Addendum No. 1

“Phase 1b – Contract D – Elevated Water Storage Tank
Illinois Alluvial Regional Water Company
Jersey County, Illinois

September 29, 2026

The contract documents prepared by MECO-Heneghan Engineers for Phase 1a – Contract D – Elevated Water Storage Tank for the Illinois Alluvial Regional Water Company are hereby amended or clarified as follows:

4
C3 **TANK MIXING PIPING DETAIL**
SCALE: 1/4" = 1'-0"

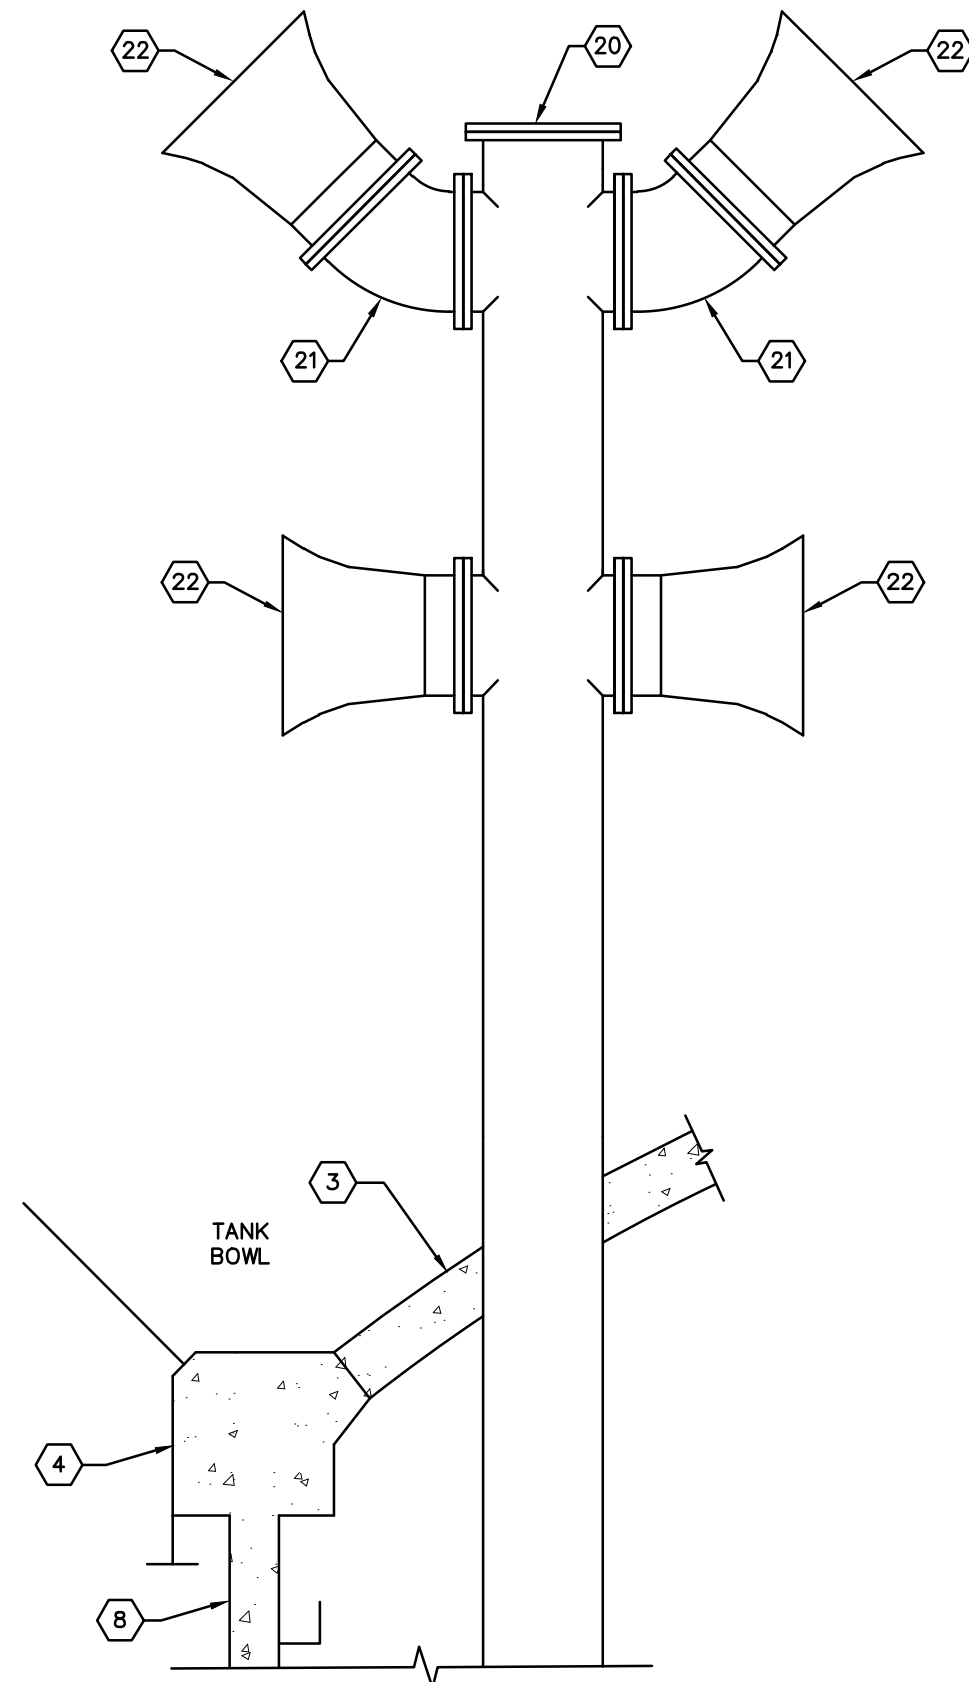
- LLL. Drawing Sheet C3 identifies the mixing system duckbill valve as a 30" Tideflex Series 35 or equal. Our standard mixing system utilizes Onyx duckbill valves. Only duckbill valves meet the requirements of Section 331619 Item 2.08T and are considered to be an equal to Tideflex throughout the industry. Can you confirm that Onyx DBF will be considered an equal for the duckbill valves for the mixing system? **Yes, provided they are equivalent and meet BABA procurement requirements.**

6
C3 **TANK LOGO ELEVATION (OPTIONAL)**
SCALE: 1/16" = 1'-0"

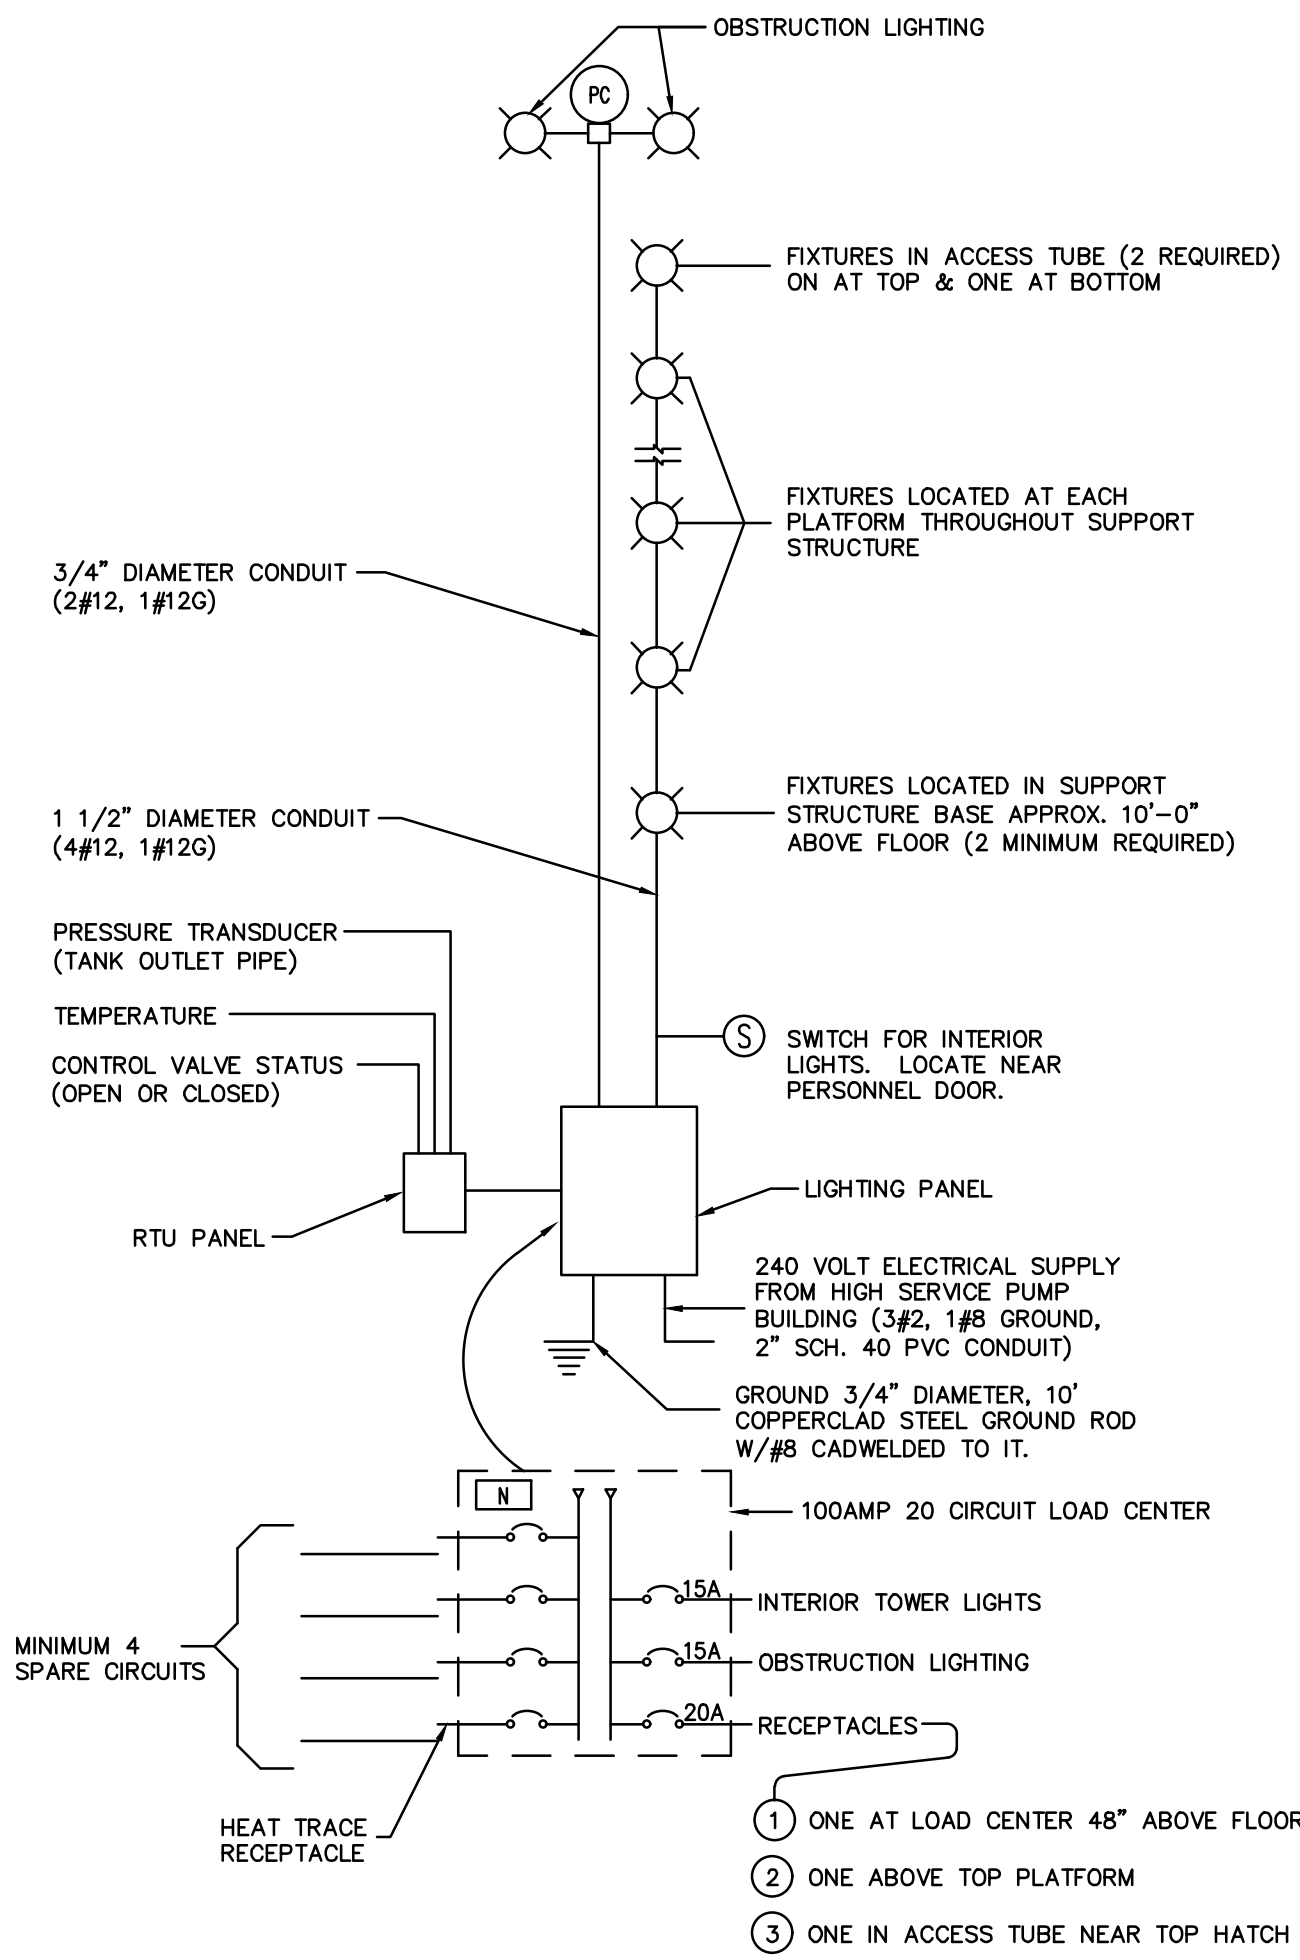
- C. Plan sheet C2 is revised per the attached Sheet C2 and clarifies valve references and riser ladder and landing geometry.
- D. Plan sheet C3 is revised per the attached Sheet C2 and clarifies valve references and detail 6/C3 – This detail governs the tank logo. Final rendering and letter height and width will be confirmed during the shop drawing review phase. The tank shell exterior color shall be Tnemec Tank White, with blue IARWC lettering and black ILLINOIS ALLUVIAL REGIONAL WATER COMPANY lettering below the logo. The water spigot and drinking glass logo shall be black. The reflection under the IARWC logo letters can be omitted.

- RR. If yes, Section 331619 Item 3.12 K talks about a Cardinal logo and “Home of the Cardinals” lettering, which does not match the logo shown on Drawing Showing C3. Can you confirm the alternate for the logo shall be as shown on C3? **See Addendum 1 for revised Section 331619.**

1
C3 **ELECTRICAL SCHEMATIC**
N.T.S.

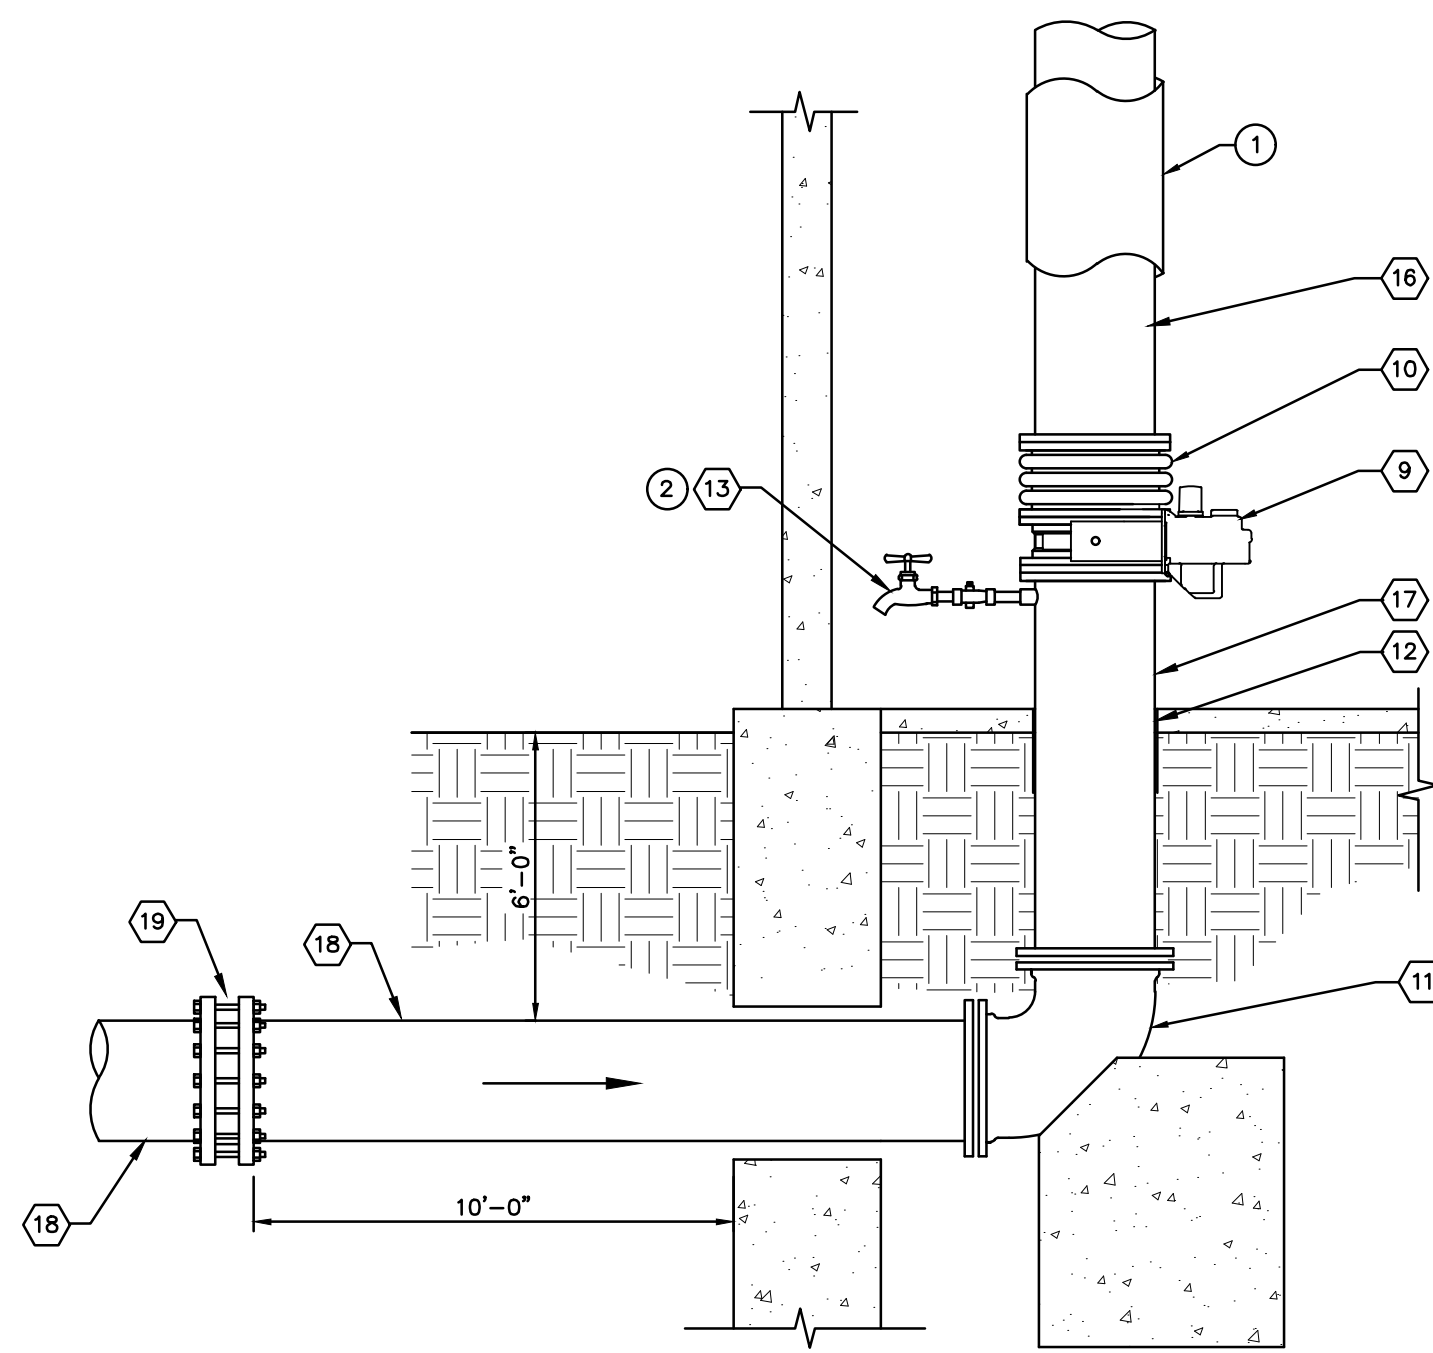
- EEE. Drawing Sheet C3 Detail #1 shows an RTU panel for a pressure transducer, and temperature and control valve status. However, there are no specifications given for this scope of work. Can you confirm that this instrumentation is by Others and not included in this contract? **SCADA will be covered by Contract C1.**
